Sent: 14/10/2022 7:01:15 PM
Subject: 1102 Barrenjoey Rd submission
Attachments: DA 20220469 - 10 Oct 2022.pdf;

10 October 2022
Attention: Jordan Davies

RE: 1102 Barrenjoey Rd, Palm Beach (DA 2022/0469)

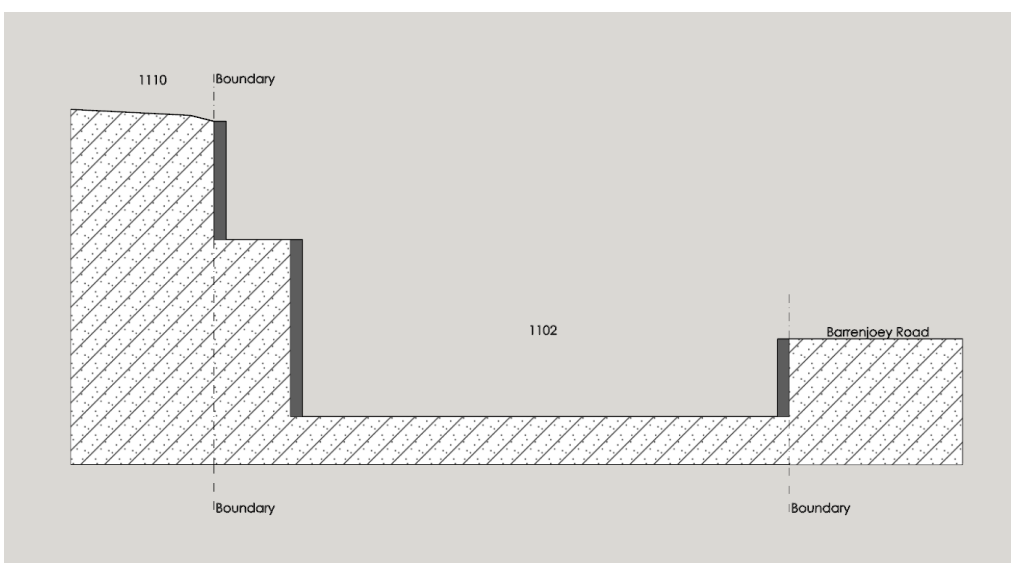
4. Inadequate rear setback and lack of privacy.

The proposed excavation on the rear boundary and narrow building setback of 3m, opens up close proximity views down to the private space of the proposed development and vice-versa.

An existing green barrier hedge (living green wall) is proposed to be removed and replaced by shallow planters at the top of the retaining wall. This in no way will achieve the visual and acoustic barrier that the existing hedge provides. Planter-box plantings are unlikely to reach any material height or health given the shallow container. Privacy, noise and close proximity is a concern.

The proposed DA doesn't detail what wall solution will be provided on the rear boundary to ensure safety and privacy (to approx 13 RL).

If construction of the proposed retaining wall is permitted it presents a considerable risk to my property from possible collapse during its construction. Given the significant excavation required a detailed description of methodology must be provided at DA stage, not at construction certificate stage. The information provided in the current Geotech report response and the assertion that "internal supports may be used" to avoid using rock bolts is vague and unacceptable for such a significant excavation.

It isn't clear how the retaining wall will be anchored and no approval has been provided by us for anchoring to be secured within our boundary.

I have provided an east-west section drawing below to show the extent of the proposed excavation.

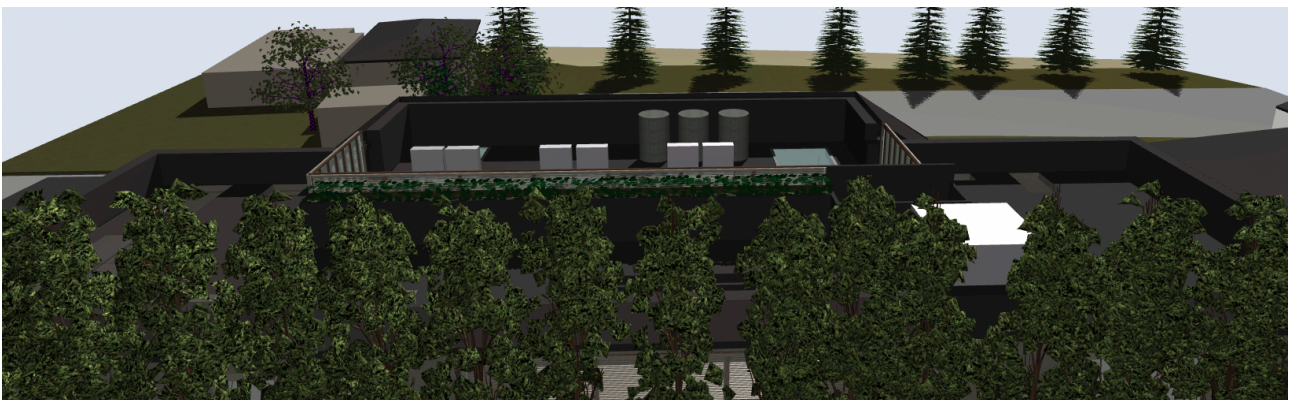
7. Large and ugly rooftop when viewed from above.

The picture below is a to-scale image of the proposed development rooftop when viewed from our home (shows the current green hedge remaining in place). This ugly view will be shared by neighbouring properties above the proposed development. In such a naturally beautiful and sensitive location (and for such a substantial development) further effort should be made to provide a natural and more visually appealing solution when viewed from above. Again, this issue is exacerbated by the height of the development.

A green roof without mechanical plat equipment would be more appropriate.

We also note that stairwell access is provided to the roof with significant open space proposed. It appears the roof-top will be open to use for entertainment, which will create a raft of other issues such as noise, safety etc.
